**From:** Detterman, Mark, Env. Health  
**Sent:** Monday, April 25, 2016 3:46 PM  
**To:** 'Divya Bhargava'  
**Cc:** Shawn Munger; Roe, Dilan, Env. Health; Kristen Gates, P.E. (kgates@hanoverco.com)  
**Subject:** RE: Drilling Permit for 25 DP Geoprobe bores

SAMPLING PLAN  
2630 BROADWAY  
OAKLAND, CALIFORNIA

PROJECT NO.: 11982.000.000	FIGURE NO.
SCALE: AS SHOWN	<b>1</b>
DRAWN BY: LL

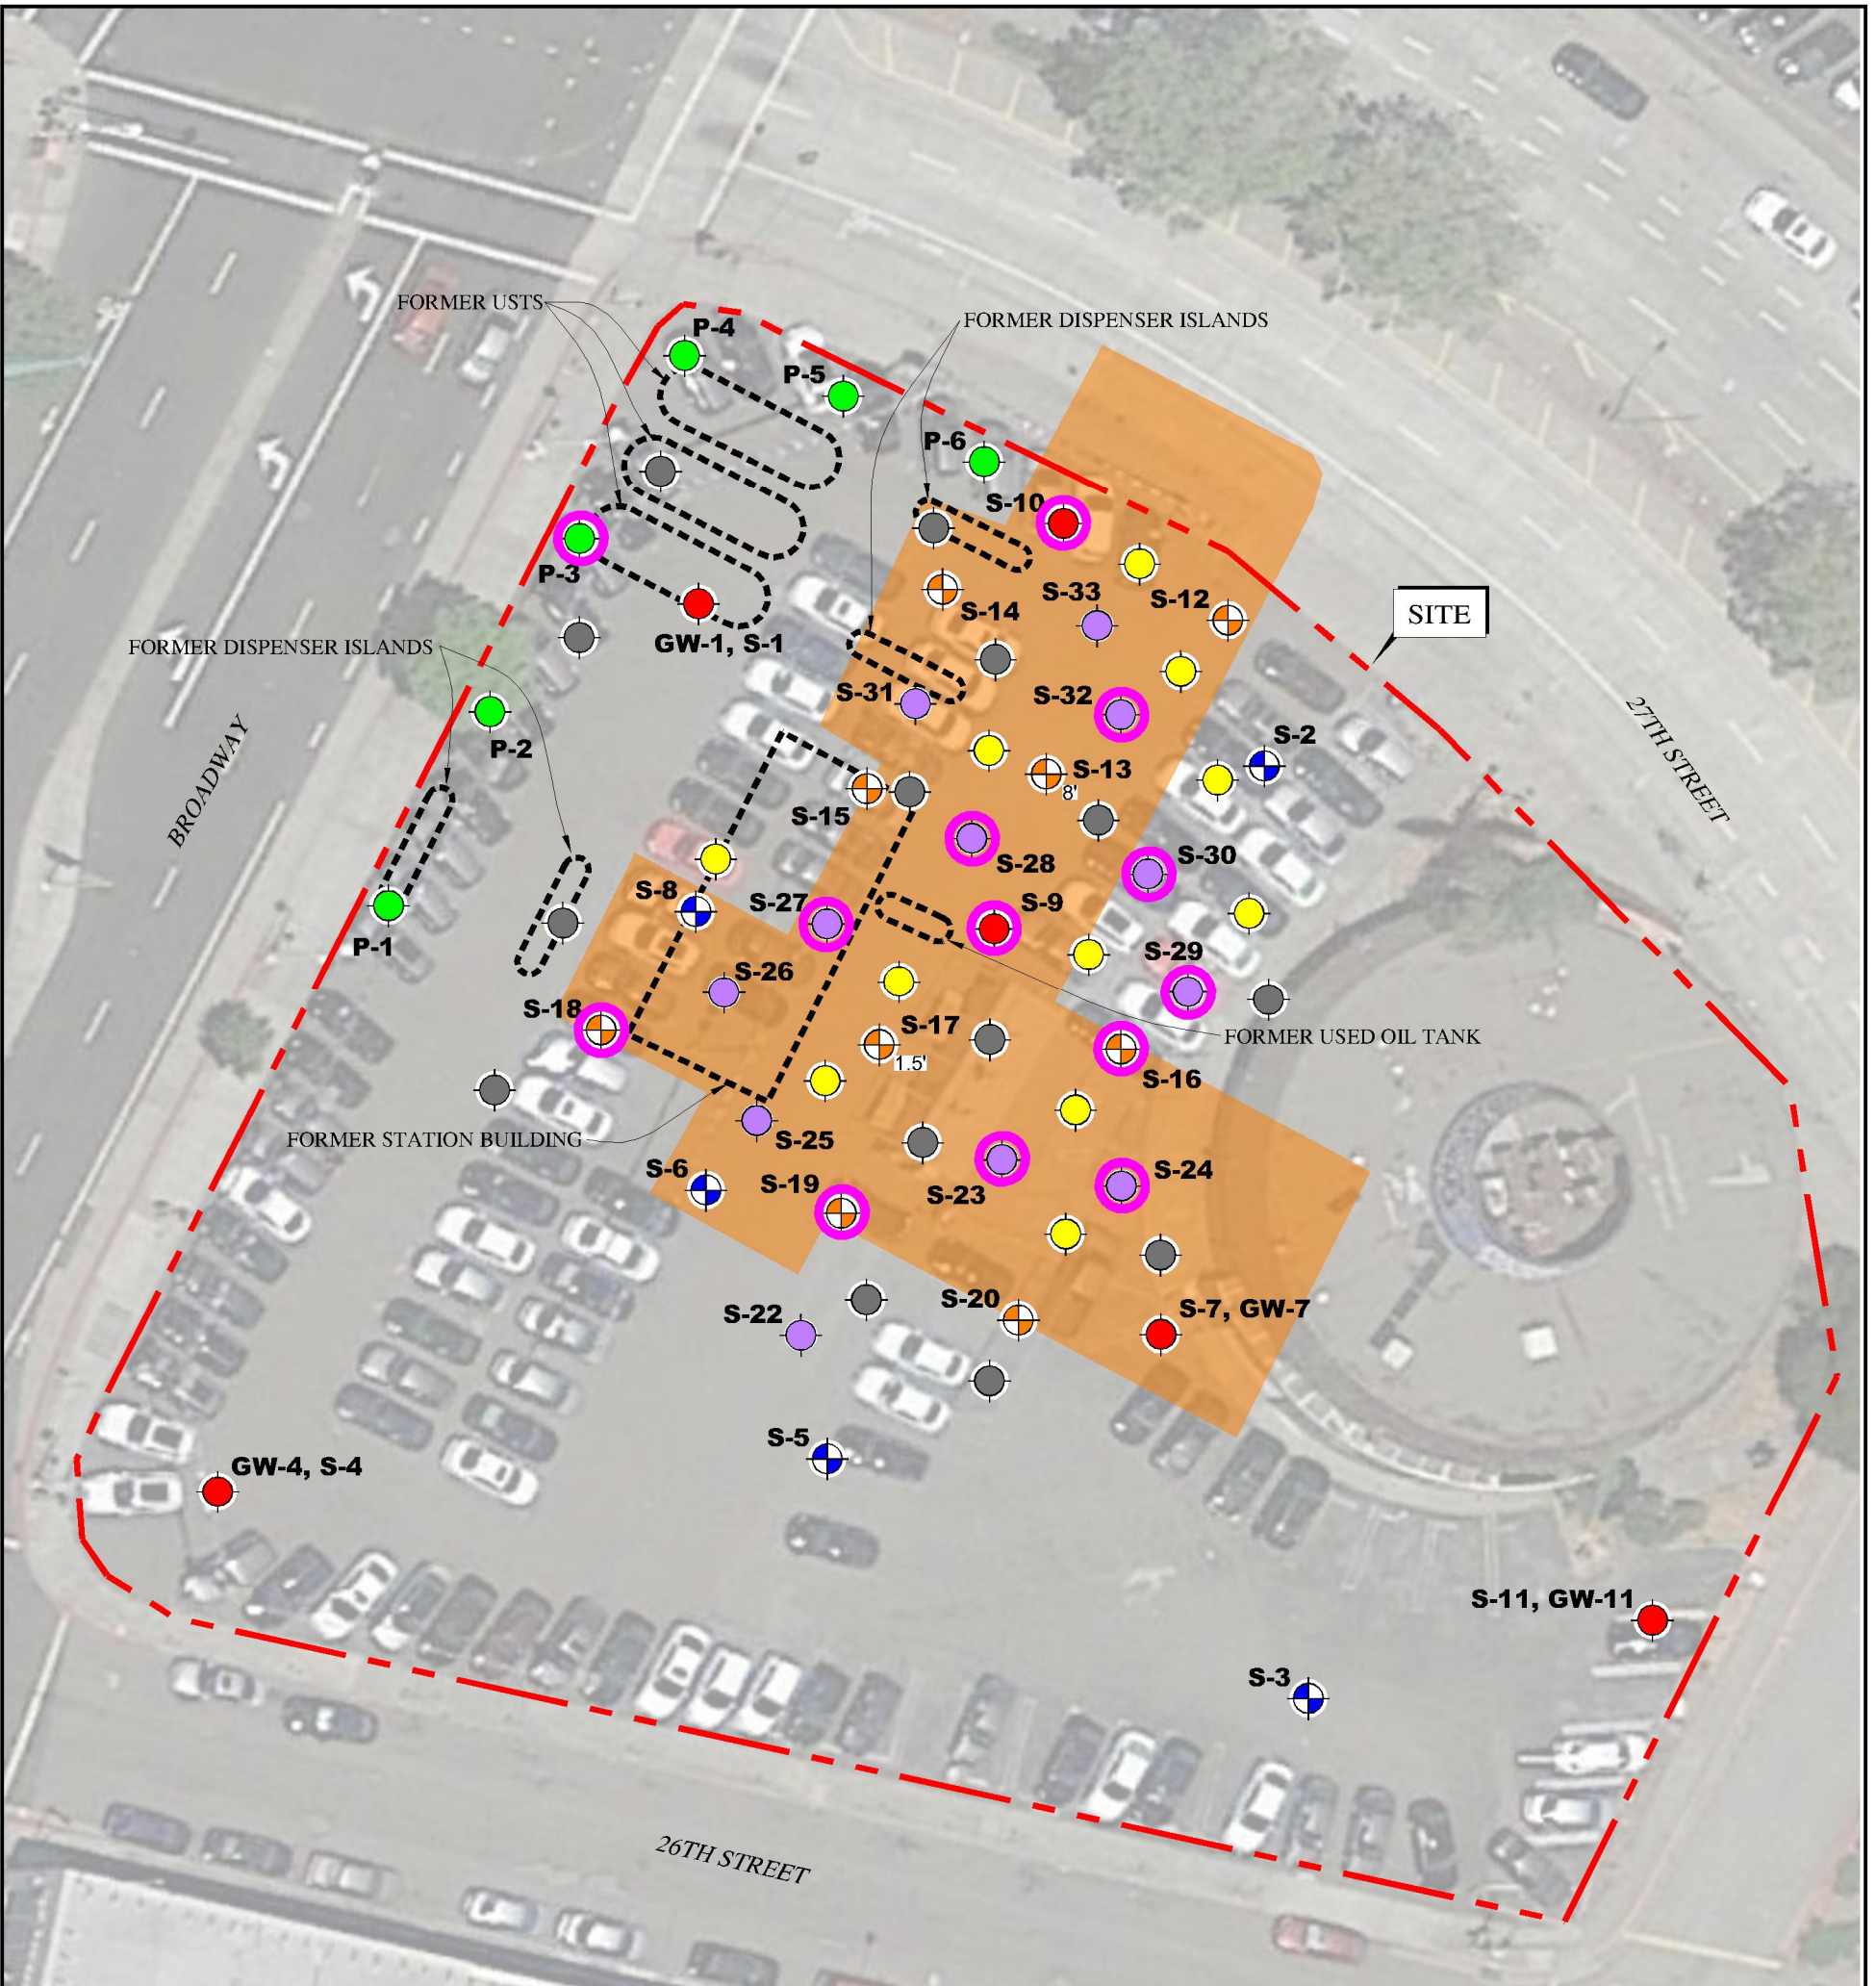
We reviewed the existing data and propose the following scope of work. A total of 25 additional borings will be installed at the site (at locations presented as gray and yellow dots on the attached figure). Samples will be collected at depths of 5, 7.5, 10, 15, and 18 feet from each boring location. All samples (a total of 125 samples) will be analyzed for lead (EPA 6010).

30% of the samples collected from the vadose zone (above the groundwater table) – a total of 22 samples (2 samples each from 11 borings shown as yellow dots on the attached figure) will be additionally analyzed for CAM-17 metals (EPA 6010/7471A) and SVOCs (EPA 8270 SIM). We do not believe that the deeper samples (below the water table) need to be analyzed for SVOCs and metals, since there are no dust concerns associated with these.

The proposed approach appears reasonable, and should provide an indication of the potential for the fill beneath the site to contain additional contaminants of concern as expressed in the service station closure. Please keep an option open for deeper more complete testing of the fill should a surprising result be encountered. Please incorporate the data generated into site tables, and keep us posted once you get the data so we can keep the site moving in your identified timeline. I've already let James Yoo know. Good luck out there.
